06PL029

I have been reviewing the documents on the planning commission's meeting and agenda website and I am very concerned about proposal #06PL029 – South Terrace Subdivision.

Subject: RE: South Terrace Revised Layout

Attachments: Photographs of topography
Copies to: South Hill and Edinborough Residents

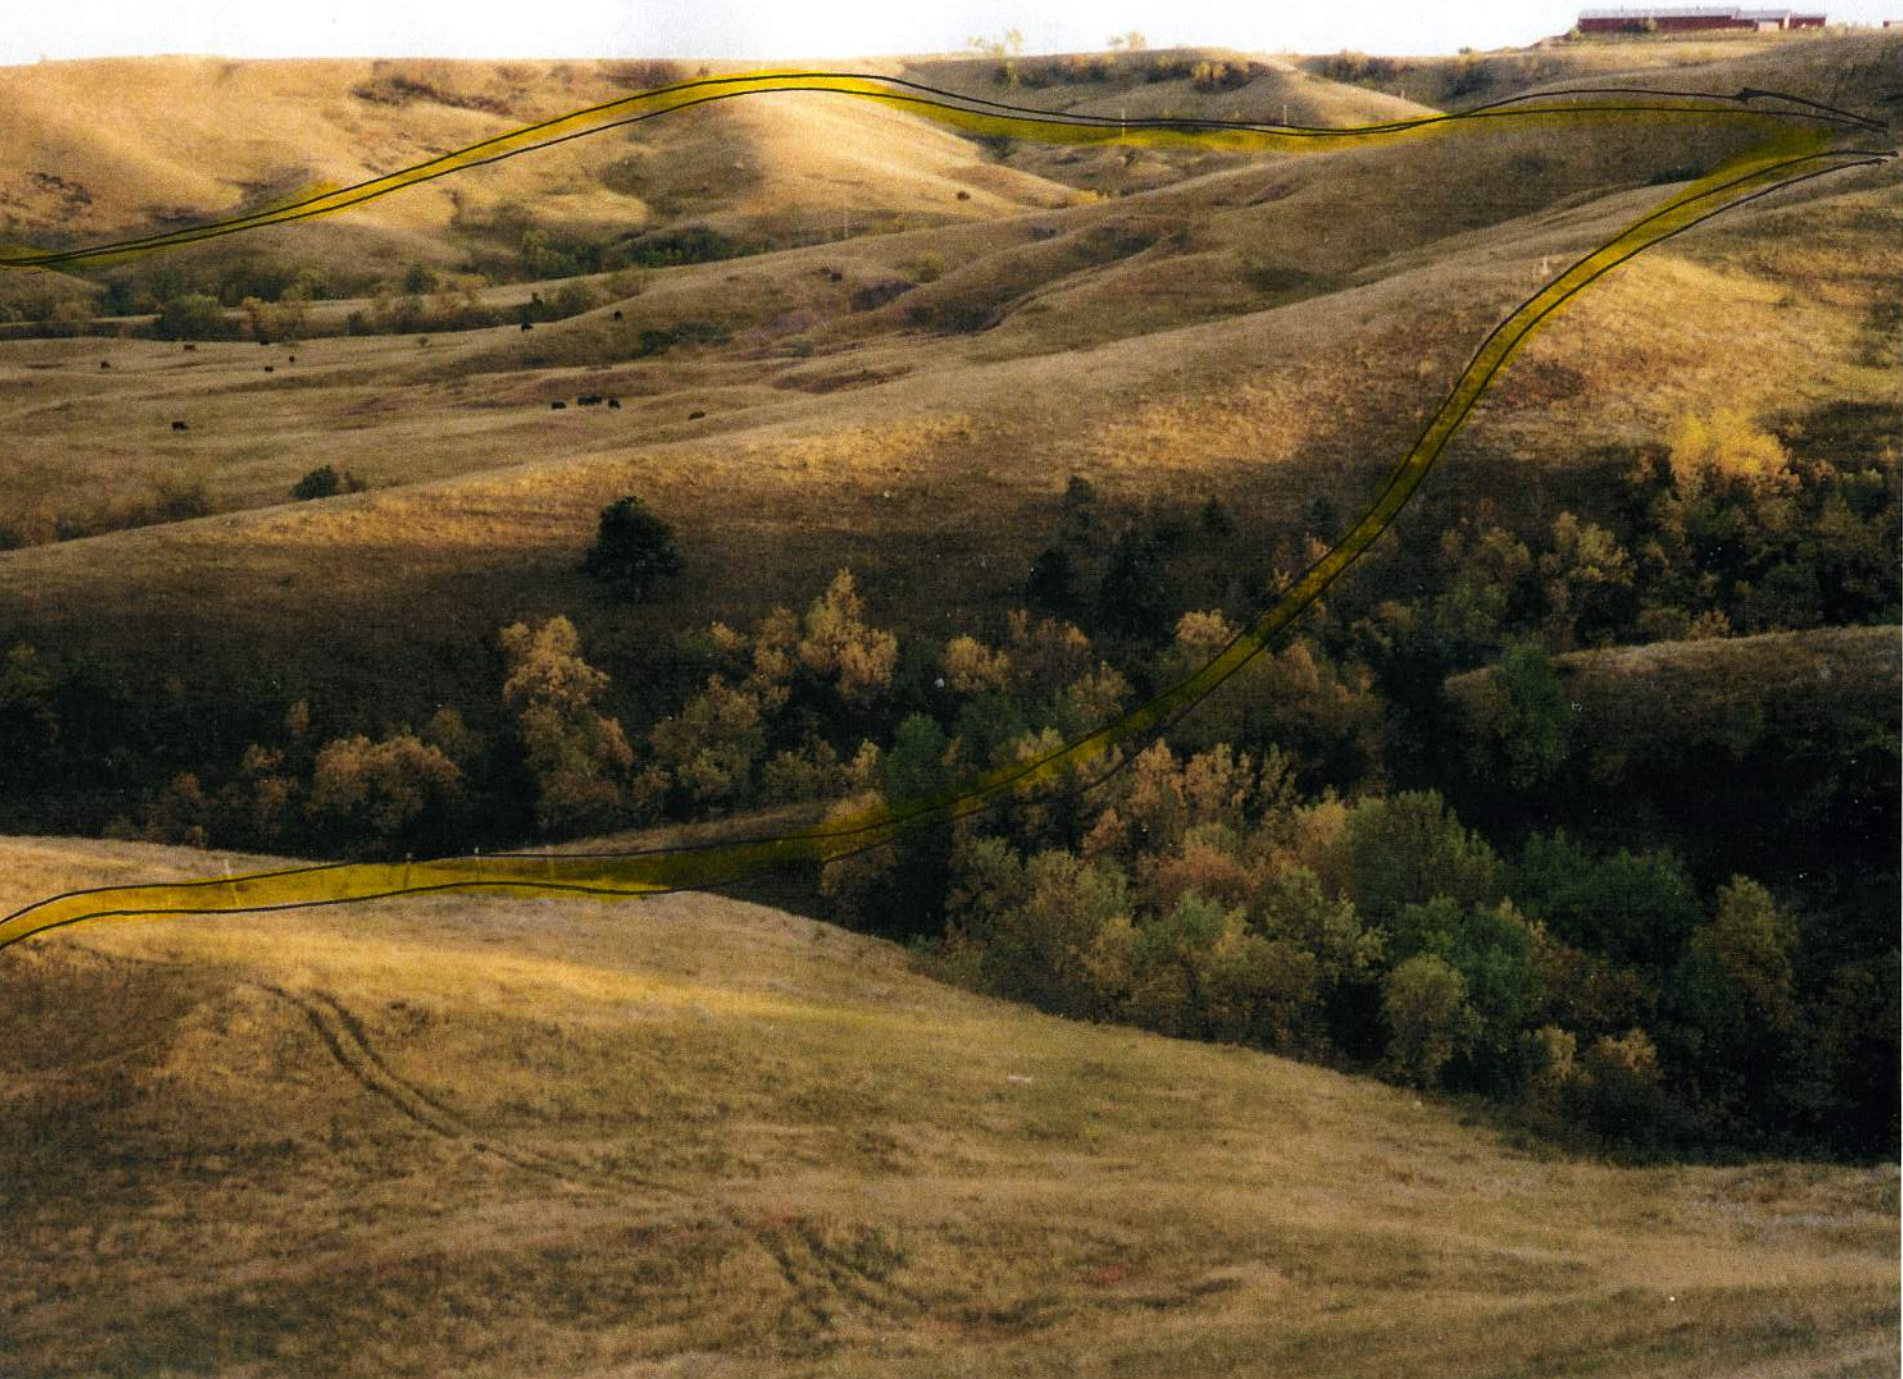
THIS AREA WILL BE LEVELED ON CURRENT PLAN.

THIS IS NOT A 20' RAVINE. THOSE ARE MATURE TREES

SPRINGS ARE LOCATED IN THE CENTER RAVINE

IT APPEARS HOUSES ARE BACKED UP TO THIS CLIFF

ANOTHER VIEW OF CLIFF
